INSPECTION REPORT
Sedimentation Structure
N10-B1
Kayenta Mine
Navajo County, Arizona
for
PEABODY COAL COMPANY

Dames & Moore
10139-011-22

SITE PLAN N10-B1

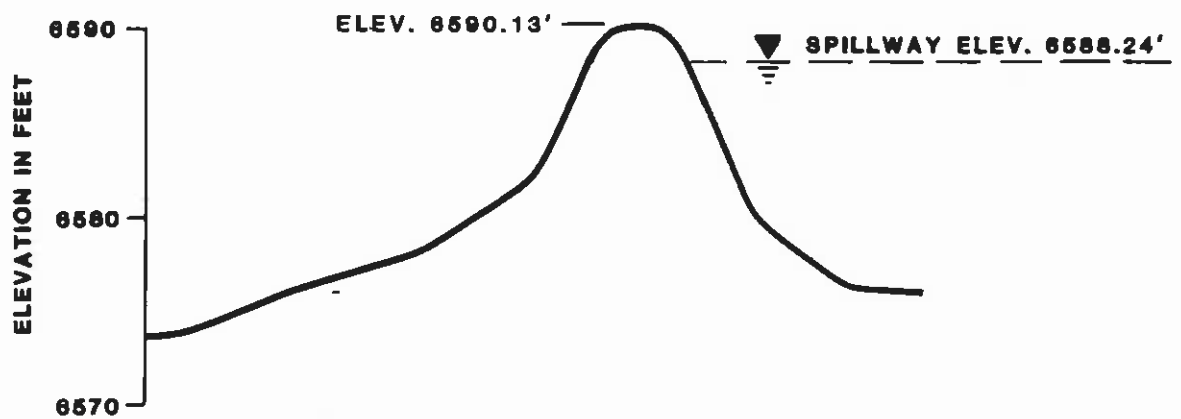
The storage capacity and spillway capacity of Structure N10-B1 are adequate; however, the spillway does not have an adequate outflow channel. A trapezoidal outflow channel should be constructed along the alignment B-B' shown in Plate 1. The channel profile is shown in Plate 4 and the required dimensions are shown in Plate 5. The outflow channel should be protected against erosion using geotextile and gravel as shown in Plate 5.

EXISTING
MAXIMUM CROSS-SECTION
A-A'
N10-B1

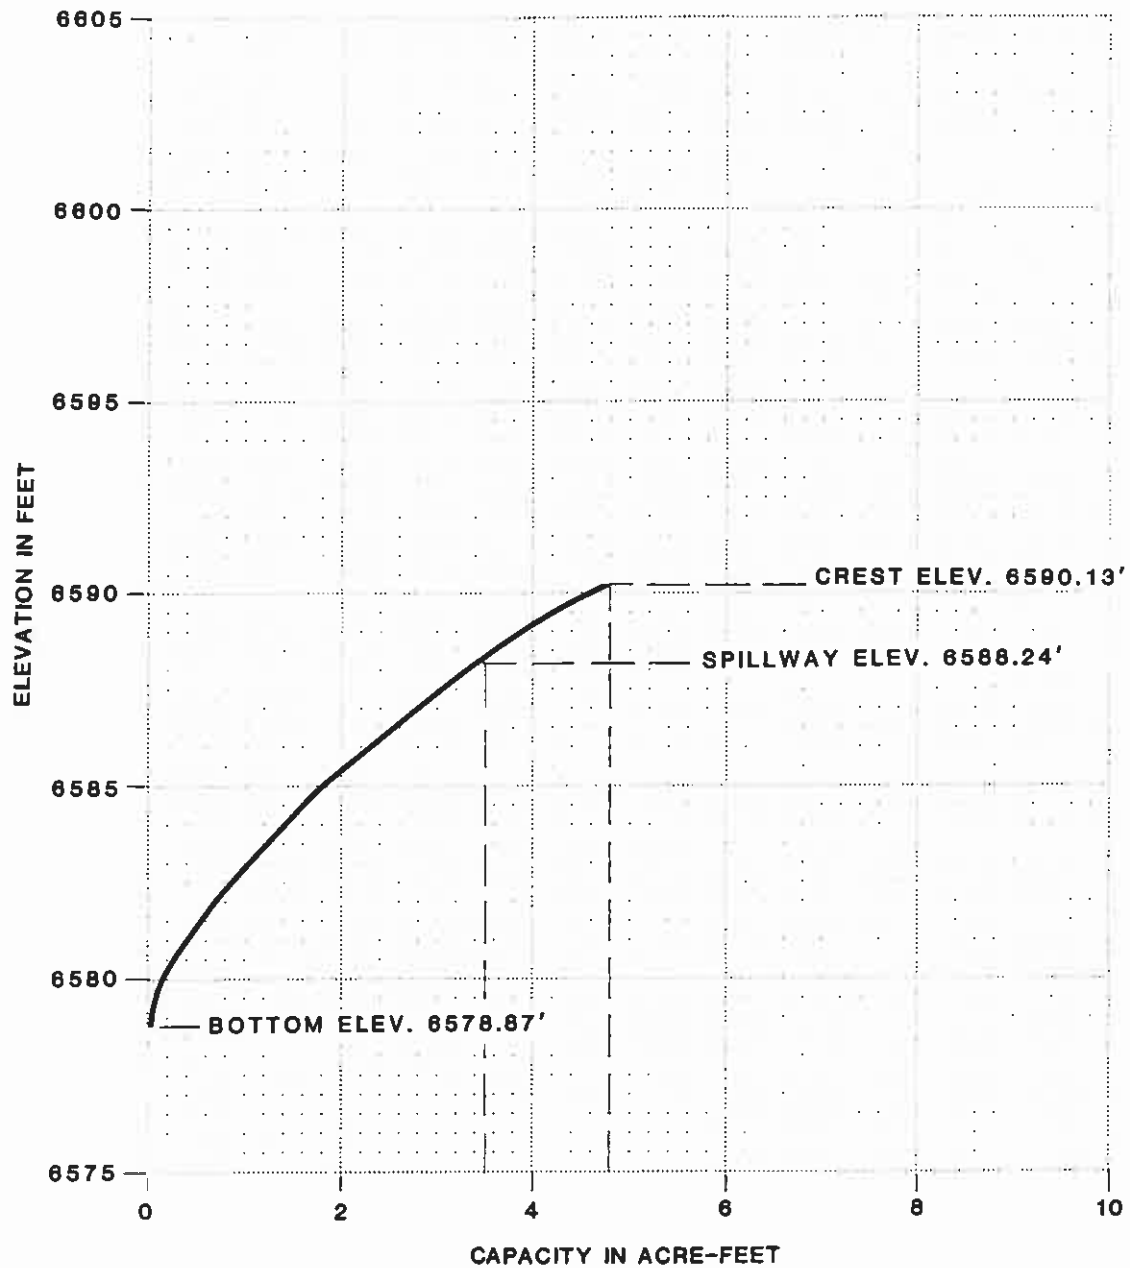
The N10-B1 embankment is lower in height; however, the downstream slope is steeper than the category standard; therefore, the embankment has factors of safety less than the design minimum.

The inspection of Structure N10-B1 indicated that the only geotechnical problem is rill erosion on the upstream and downstream slopes. Correction of erosion is considered a periodic maintenance task and does not require remedial action. The downstream slope should be flattened to 3.25 horizontal to 1 vertical to meet stability requirements.
